TECHNICAL SERVICE BULLETIN

ISSUE DATE:	7/11/2023
SERVICE BULLETIN SUBJECT:	Eberspaecher Condenser HD Pipe Retrofit
VINs or MODELS AFFECTED:	Service Specified Buses
COMPLETE BY:	Next Service Opportunity
SERVICE BULLETIN #:	SC-23-29
LABOR OPERATION CODE:	VA54Z

EBERSPAECHER CONDENSER HD PIPE RETROFIT

TECHNICAL BULLETIN NR: ESTR-QUALITY-TB-001-2022 REV 01
DESCRIPTION: PROTERRA HD PIPE REPLACEMENT

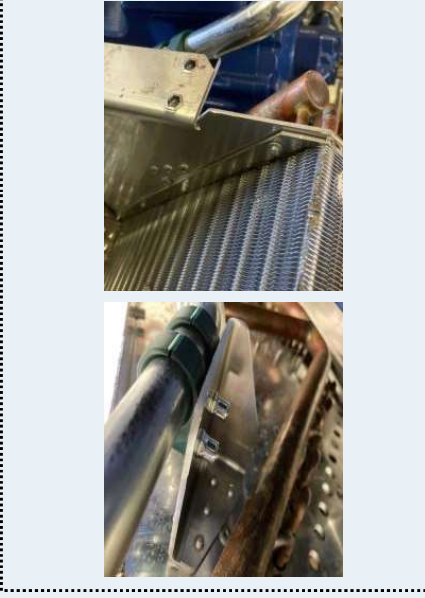
Remove HP compressor line and support bracket on the suction side service port valve.

Replace with HD pipe kit P/N 88-50-29-02161-00

Apply oil to new gaskets and connections before tighten. Tighten to specified torques according to page 9.

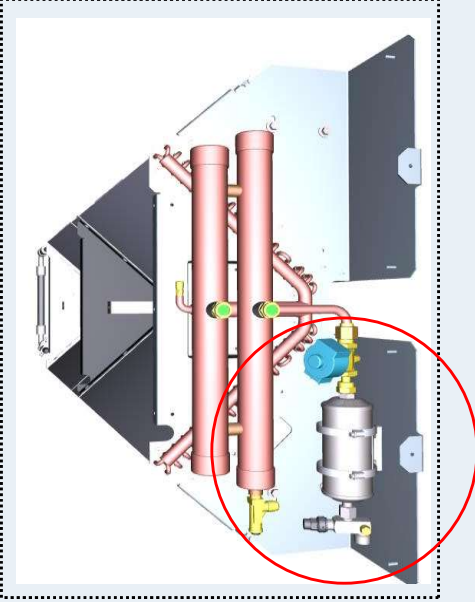
Remove Condenser fan plate slightly to gain access to reverse side of bracket. M8 bolts
Fit support bracket loosely ready for alignment.

Align pipe support bracket according to drawing (page 8)
Drill 5mm holes and secure with rivets .
Replace Condenser fan plate.

Secure and tighten pipe supports according to drawing
